OAKAJEE RAIL DEVELOPMENT

PUBLIC ENVIRONMENTAL REVIEW ASSESSMENT NO. 1818

SUMMARY OF SUBMISSIONS & MATTERS TO BE ADDRESSED

Figure 1: Two tiered approach of the Vegetation Monitoring Program (eco logical Australia 2010)

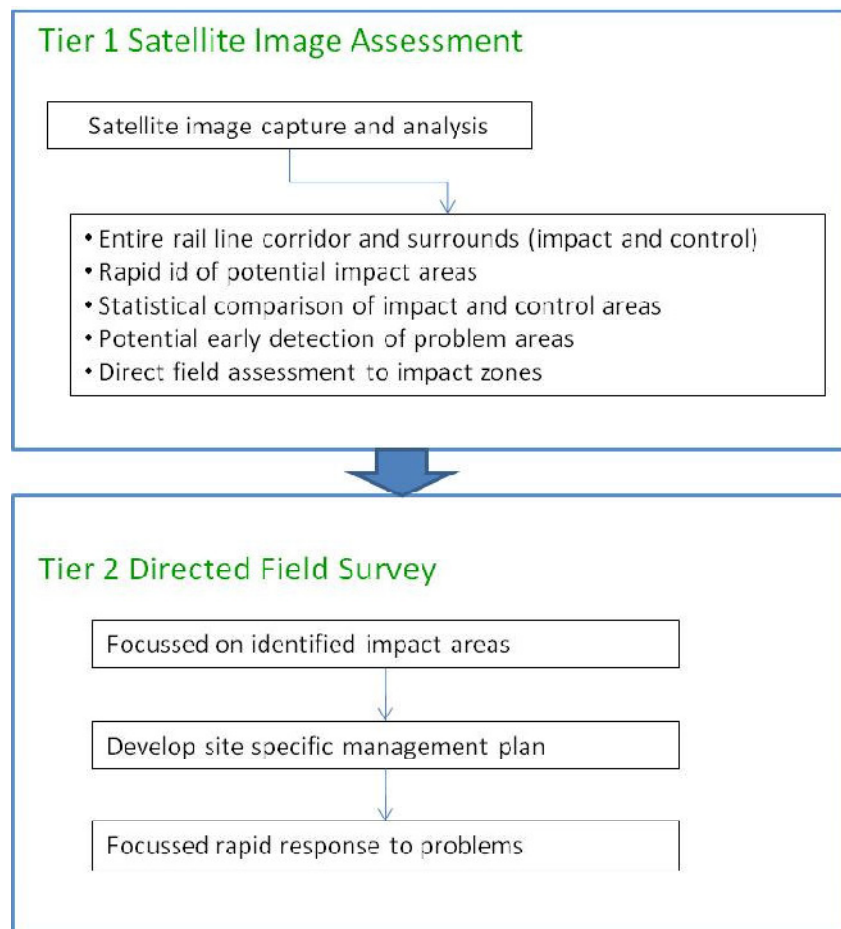
Submitter (sub #)	Submission and/or issue	PER modified
Shire of Chapman Valley (5)	Concerned that although surface water dependant vegetation is listed for monitoring to ensure the engineering design works, there is no commitment for remedial management action specified should vegetation be impacted.	No

Eco Logical Australia was commissioned to develop a Vegetation Monitoring Program (Eco Logical Australia 2010). The monitoring program has been developed to assess indirect impacts of the proposed rail formation design on sheet flow dependant vegetation communities. The monitoring program provides an integrated approach using multi-temporal remote sensing analysis with supporting directed ground surveys/assessments. This will provide vegetation condition information across the potential impact area to detect changes requiring on-ground response. Two tiers of trigger levels requiring action are proposed (Figure 1). The first is based on early change detection using remote sensing, which will trigger further on-ground investigations. The second tier of responses is triggered by results of directed ground assessment or changes detected in permanent monitoring plots/quadrats, If this response is triggered then remedial actions will be implemented to mitigate and ameliorate any significant impacts on vegetation communities.

Figure 2: Design of proposed Rail Corridor drainage facilities (Astron 2010)

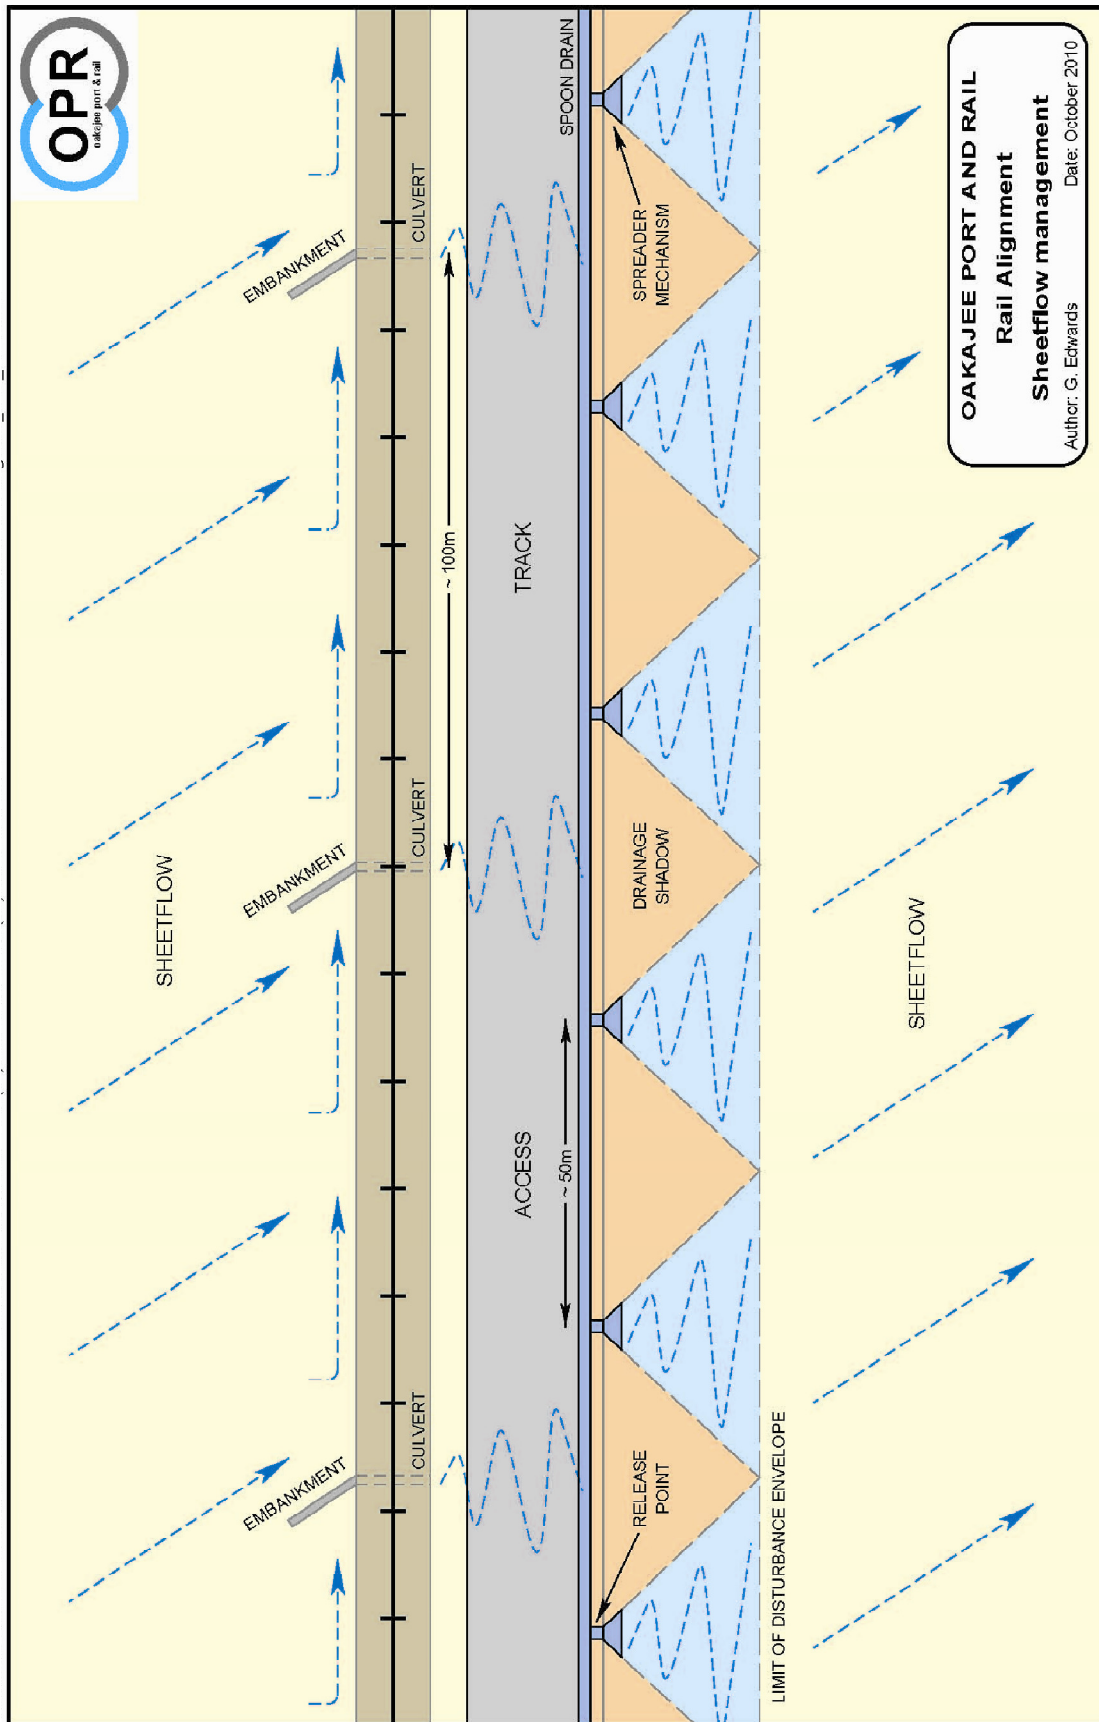
Submitter (sub #)	Submission and/or issue	PER modified
DEC – Environmental Management Branch (7)	Submitter suggests a zone of indirect impacts (adjacent to areas approved for disturbance) be defined for this project by the proponent, and within which, significant flora and vegetation condition and health may decline to agreed limits.	No

Astron (2010) then used the above information to perform GIS analysis to determine what drainage spacings would be required to re-establish the sheet flow regime resumes within the outer boundary of the construction envelope. It was determined that the final downstream release point was likely to be on

the downslope side of the access road, with an approximate 25 m distance between this point and the outer boundary of the construction envelope. The results have shown that in some high risk areas the drainage spacings will be at approximate 50 m intervals. This information has been supplied to OPR's Rail Engineers for input into their drainage design. Figure 2 depicts the detailed design principle for the environmental culverts, embankments, spoon drains, release points and spreader mechanisms to resume sheet flow within the construction envelope in areas of sheet flow dependant vegetation.

By implementing the mitigation design measures shown in Figure 2, a reduction from 2261.07 ha of areas classified as having high to critical ecological risk to 259.86 ha is achieved (Table 4). This indicates the area of residual impact to sheet flow dependant vegetation should be contained within the construction footprint based on the Astron risk assessment (Astron 2010). As this area would have previously been cleared for construction it is predicted that there will be no additional disturbance expected, however it may impact on rehabilitated vegetation.

The PER included consideration of this issue (Section 7.5). Further information and discussion is provided above – in particular refer to Figure 2.

Figure 3 Proposal footprint cross-section

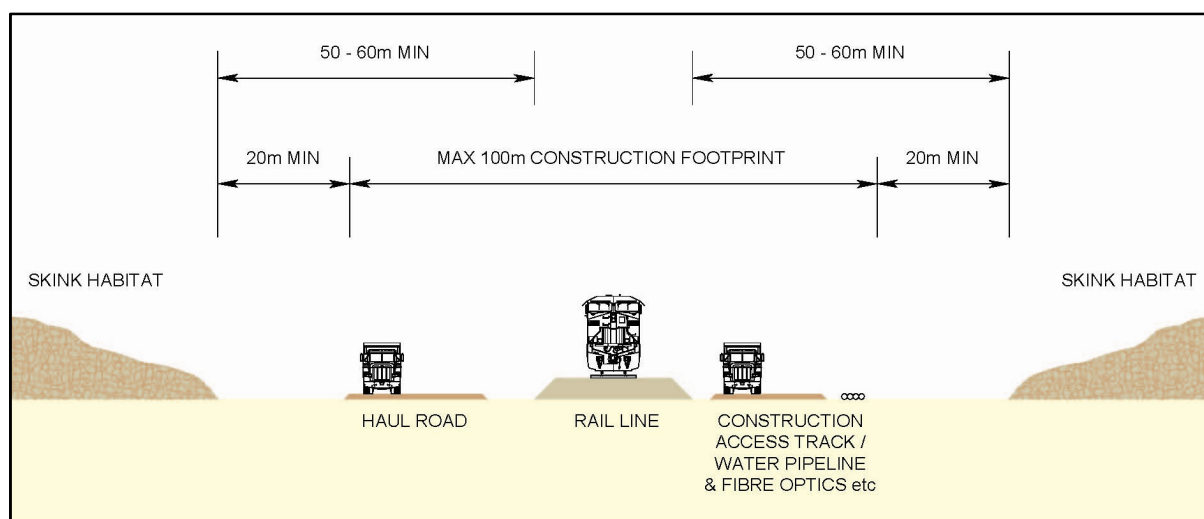
Submitter (sub #)	Submission and/or issue	PER modified
DSEWPC (2)	<p>PER states that “<i>with the exception of the rail corridor no disturbance will occur within a 200m buffer of known <i>Ergenia stokesii</i> badia habitat. If the rail corridor must pass through these areas a 50-60m buffer will be maintained between the rail line and specific habitat used for shelter (rock outcrops), and the construction disturbance width will be limited to an average of 100m</i>”</p> <p>This commitment is confused and needs to be more clearly defined.</p> <p>Explain more clearly:</p> <ul style="list-style-type: none"> the rationale for why the rail corridor is excluded; how a 50-60m buffer from the rail centreline can be maintained if the construction disturbance width will be an average of 100m; and an assessment of the level of risk that Western Spiny-tailed Skink populations would face with a buffer of 200m and 50-60m in place. 	Yes

Details of the Proposal footprint and minimum separation distance from habitat are shown in Figure 3. Note that this situation occurs in only a portion (several hundred metres) of the populations within the Proposal Area. In all other situations planning has managed to avoid habitat by more than 200 m.
